From: Deepa Randhawa <DRandhawa@cityofparramatta.nsw.gov.au>
Sent: Friday, 23 July 2021 12:22 PM
To: Minoshi Weerasinghe
Subject: FW: DA 10649 – M2 Motorway Epping – Digital Advertising Signs - Additional information request

The Department has requested Council to provide further information regarding our previous submission on the Proposed Digital Advertising Signs on the M2 Motorway, Epping.

Figure 2: StreetView image of M2 Motorway Eastbound near the proposed advertising sign as well as the location of the critical points near the sign that are impacted by the proposal

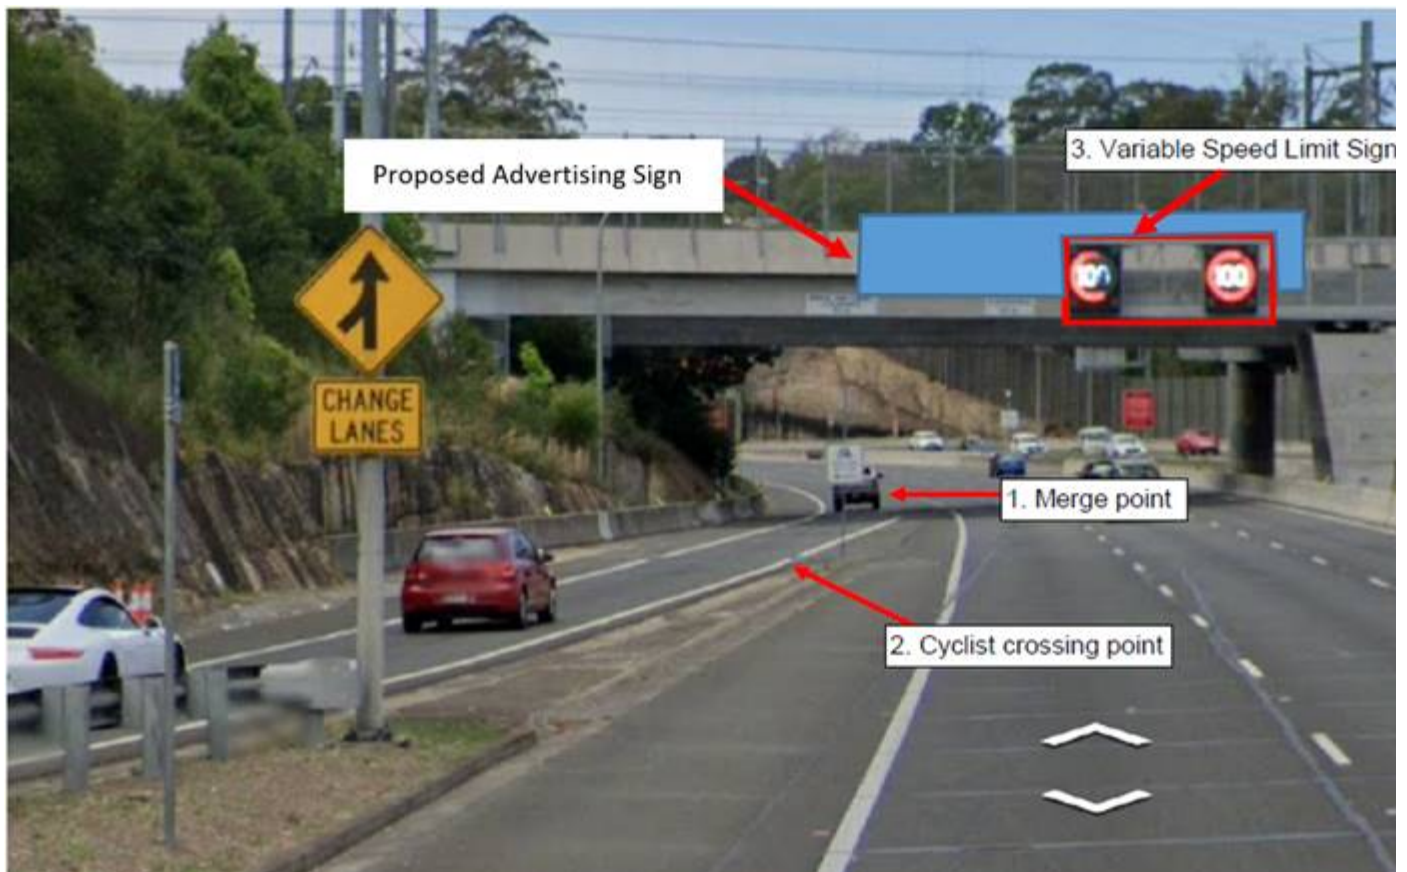
It is noted that both the Applicant’s response and the Department acknowledges that the signage on the western elevation is located less than the safe site distance from decision making or conflict points with regards to the entry ramp and the location of the merge point. However, the department requested further information from Council regarding why the sign is considered non-compliant with the cycle crossing.

The sign will be visible to a motorists while they are navigating the cyclist crossing as demonstrated in the below figure. Accordingly, the sign will be distracting near a conflict point as per the above extract from the guidelines.

Furthermore, where the guide in section 3.2.3 (a) states “the signs should not be placed: (ii) less than the safe stopping sight distance from a marked foot crossing, pedestrian crossing, pedestrian refuge, cycle crossing, cycleway facility or hazard within the road environment”, the interpretation should be the safe stopping sight distance both before and after the conflict point. This is to ensure consistency with previously quoted paragraph which states that signs should not distract drivers near conflict points. A sign located after a conflict point but still visible to motorists when they are navigating it, will still be distracting.

The current proposed location of the sign is after the cyclists crossing point but it will be in view of motorists within a safe stopping sight distance and therefore, will be distracting motorists at a critical time where greater attention is required on the driving task. As such, the proposed sign does not comply with the requirements stated within section 3.2.3 of the guidelines.
